Kern River 2003 Expansion Project

FERC/EIS-0144
Docket No. CP01-422-000

Final Environmental Impact Statement/ Environmental Impact Report

In Reply Refer To:
OEP/DEER/Gas Branch 1
Kern River Gas Transmission Company
FERC Docket No. CP01-422-000
CA Clearinghouse No. 2001071035
CSLC EIR No. 710
BLM Reference Nos. CACA-43346
and CACA-17918

Figure 2.2.2-1
Kern River 2003 Expansion Project
Coyote Creek Compressor Station Site Plan

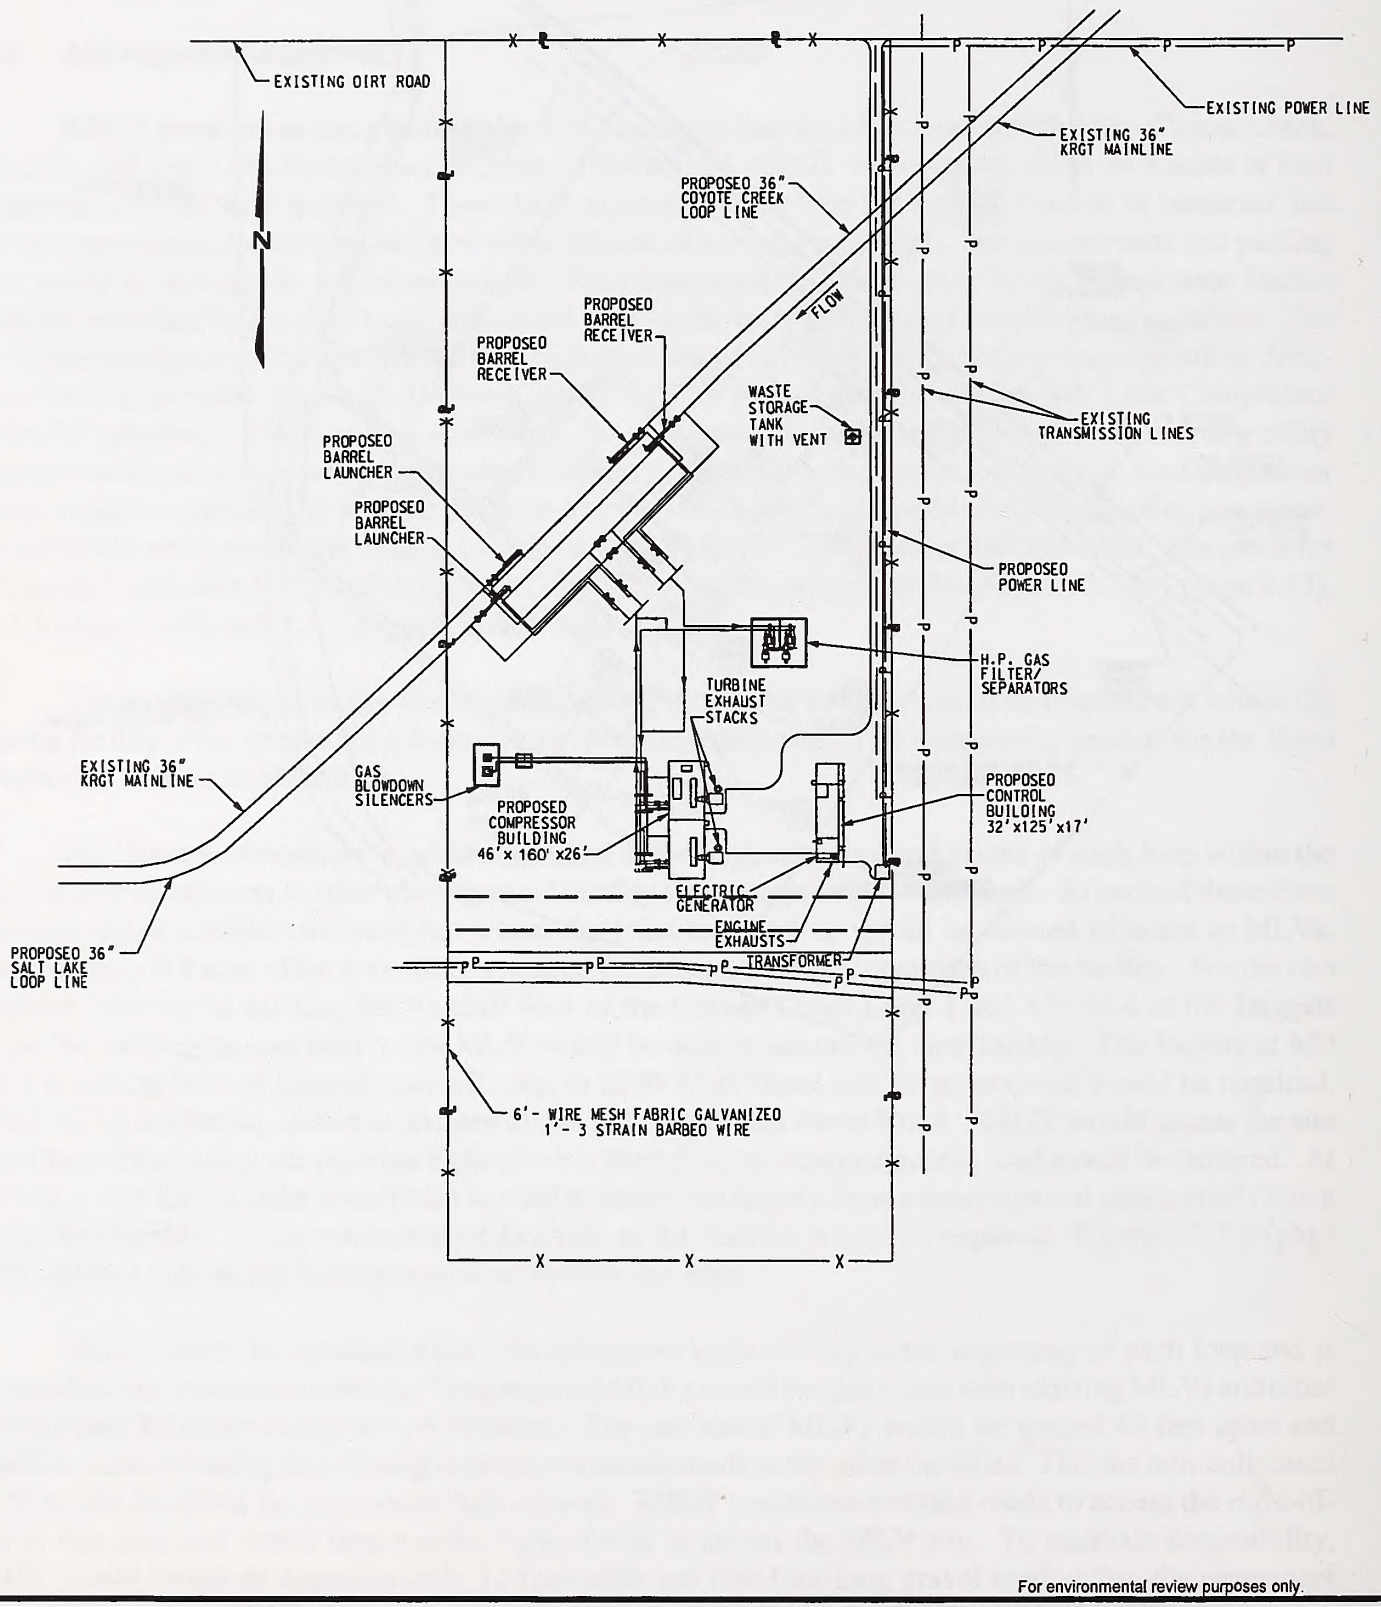
KRGT requests that building dimension depicted in Figures 2.2.2-1 (Coyote Creek) and 2.2.2-2 (Salt Lake) on Pages 2-17 and 2-18, respectively be revised to reflect the current building dimensions for these two compressor stations. Figure 2.2.2-3 (Dry Lake) is correct and does not require revision.

Figure 2.2.2-4
Kern River 2003 Expansion Project
Typical Pig Launcher/Receiver Site Plan

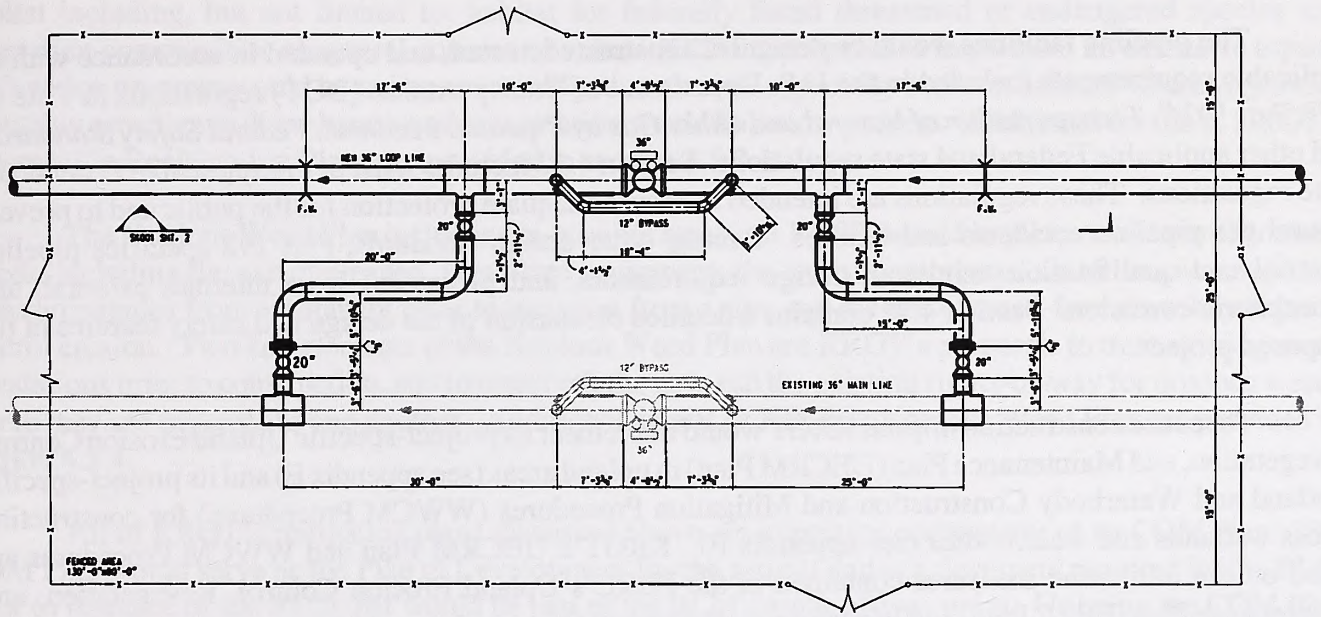
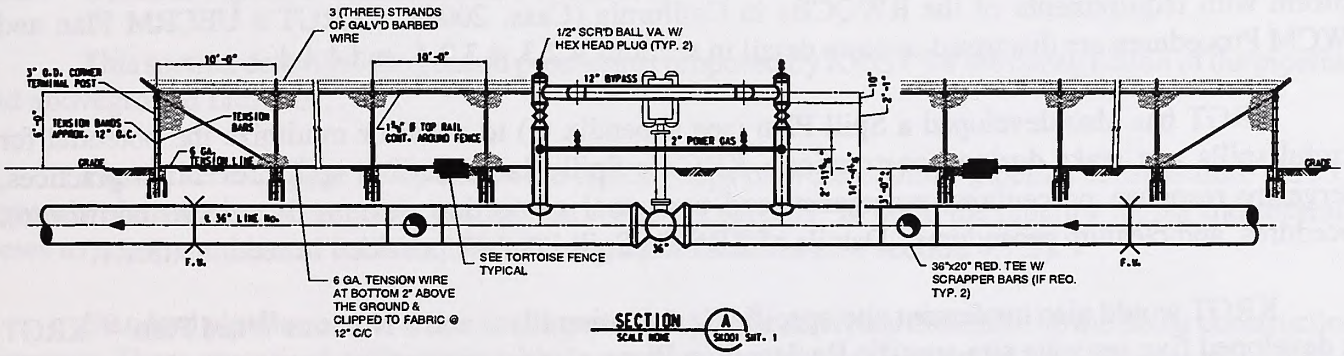
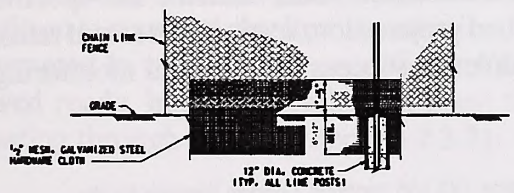
A1-16 Page 2-20 Figure 2.2.2.4/Page 2-21 Figure 2.2.2.5 - Typical Section (Tortoise Fence)
The insets in the figures that specifically address the installation of tortoise fencing indicate a minimum excavation depth of 1 foot. Per the February 26, 2002 meeting with USFWS, KRGT anticipates the final Biological Opinion will reflect a requirement of 6-12 inches of excavation. KRGT recommends Figure 2.2.2.4 be revised to reflect a minimum 6-12" excavation.

A1-16 Figures 2.2.2-4 and 2.2.2-5 have been revised. See also the response to comment FA5-39.
